OPTIONAL SERVICE BULLETIN NO. OSB 62-058 REV. 1
SUPERSEDES OSB 62-058 REV. 0

Installation of the Garmin GTX 345DR Diversity transponder with the top transponder antenna.

WORK INSTRUCTION WI-OSB 62-058 REV. 1
SUPERSEDES WI-OSB 62-058 REV. 0

Installation of Garmin GTX 345DR Diversity transponder (OÄM 62-1033) for airplanes equipped with GTX 335R/ 345R, with or without Avidyne TAS 6XX(A) system.

Figure 1.

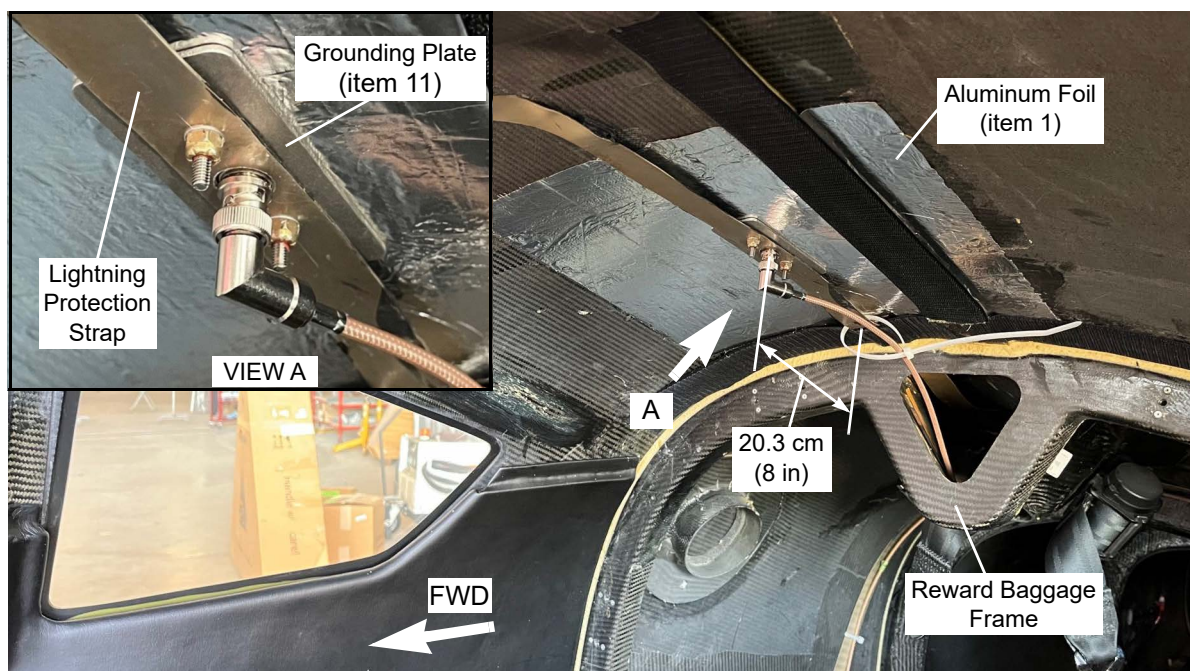
1. Incorporate AMM-TR-OÄM-62-1033 into the Airplane Maintenance Manual or use an AMM revision in which AMM-TR-OÄM-62-1033 has been incorporated.
2. Disconnect the airplane main battery. Refer to AMM Section 24-31.
3. Install the top transponder antenna as follows:
 - 3.1. To get access to the lightning protection strap on top fuselage over the RH third row passenger seat, remove the headliner.
 - 3.2. If MÄM 62-1126 is not installed, do as follows:
 - A. Mark the holes on the lightning protection strap in accordance with the hole pattern of the grounding plate (item 11), keeping the center hole 20.3 cm (8 in) from the forward-edge of the reward baggage frame.

- B. Drill holes in the airplane skins through the lightning protection strap.
- 3.3. Remove the bonding adhesive/resin from the lightning protection strap to detach it from the airplane skin along the required length to install the aluminum foil (item 1).
- 3.4. Install a 30.5 cm (12 in) x 30.5 cm (12 in) aluminum foil (item 1) using adhesive 3M Super 77 adhesive. Keep the center hole as the center point of the aluminum foil.
- 3.5. If MÄM 62-1126 is not installed, put the grounding plate (item 11) in the installation position.

Figure 2.

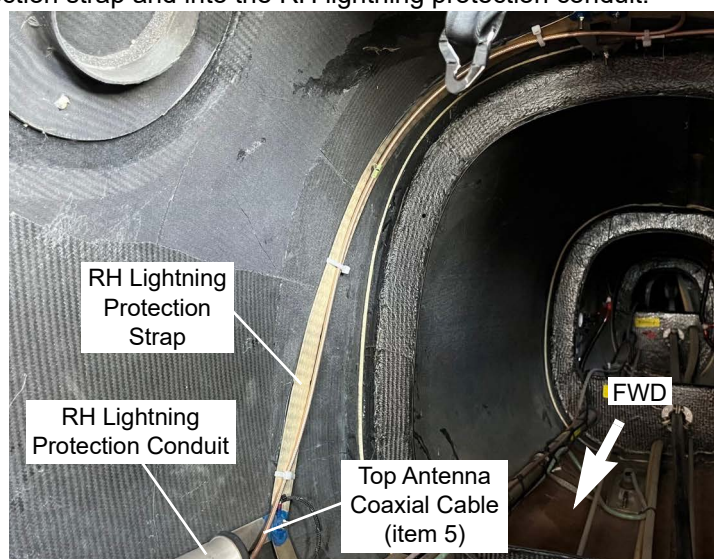
5.1. Route the coaxial cable to aft through the reward baggage frame (refer to Figure 1). Follow the RH lightning protection strap and into the RH lightning protection conduit.

Figure 5.

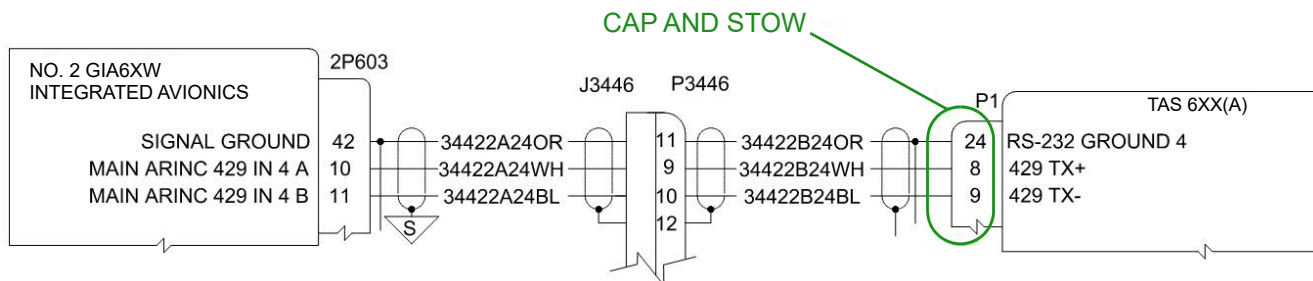
A. Cap and stow existing ARINC 429 wire.

Figure 8.

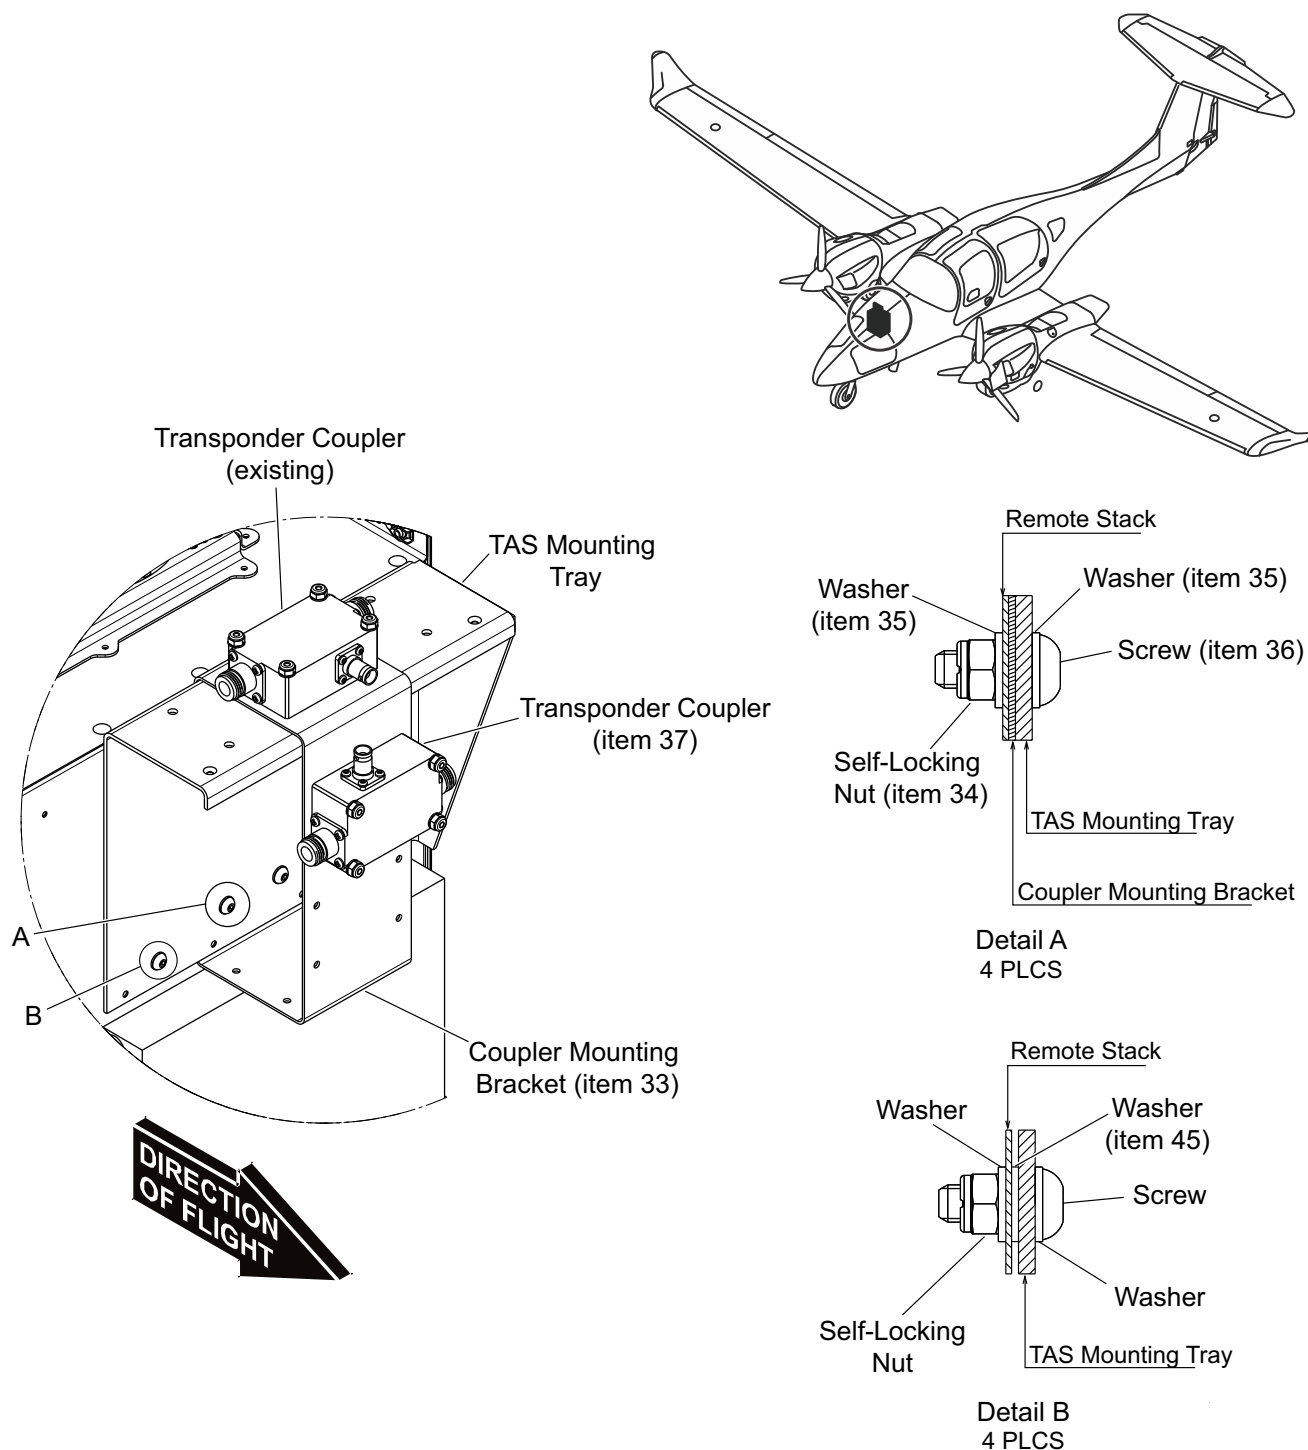
9.3. Install the screws (item 36), washers (item 35), and self-locking nuts (item 34) which attach the coupler mounting bracket (item 33). Refer to Figure 8.

9.6. With instant adhesive (Loctite 495), attach the washers (item 45) to the backside of the TAS mounting tray. Refer to detail B of the Figure 8.

9.7. With the existing TAS mounting tray screws, washers and self-locking nuts, install the TAS mounting tray. Refer to detail B of the Figure 8.

Figure 9.

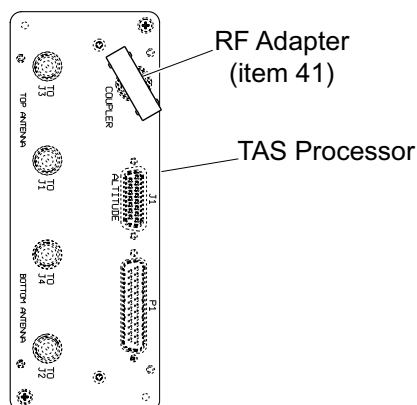
9.9. Connect the RF adapter (item 41) to the coupler receptacle on the TAS processor. Refer to Figure 9.

Figure 10.

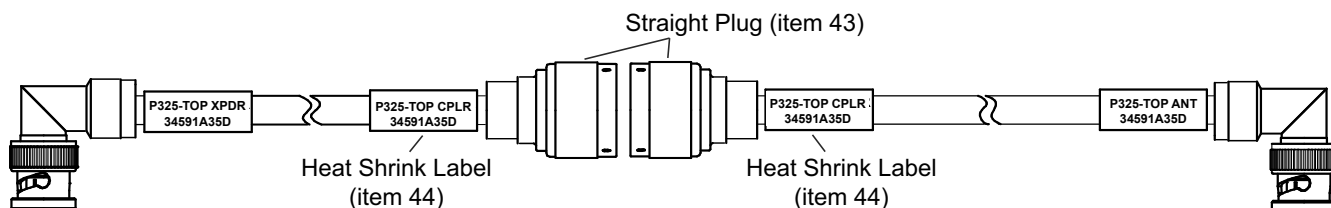
9.10. Cut the top antenna coaxial cable (item 5) to a length sufficient to interface with the ANT end of the new transponder coupler (item 37).

9.11. Install the heat shrink labels (item 44) on the top antenna coaxial cables (item 5). Record the text on the heat shrink label.

Figure 11.

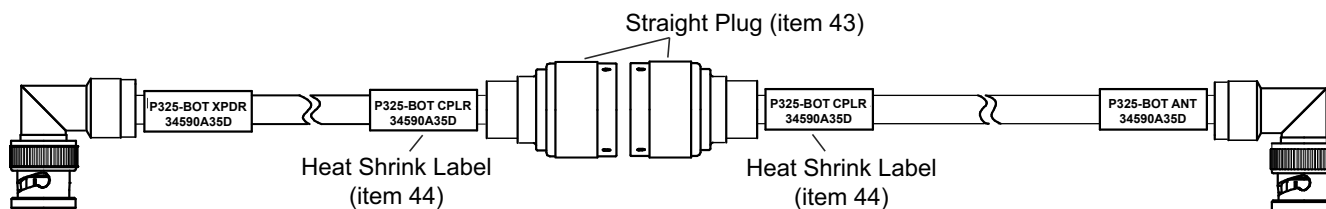
9.17. Repeat the steps 9.10 to 9.16 for the bottom antenna coaxial cable (item 12), and existing transponder coupler. Refer to AMM Section 92-00 and Figure 11.
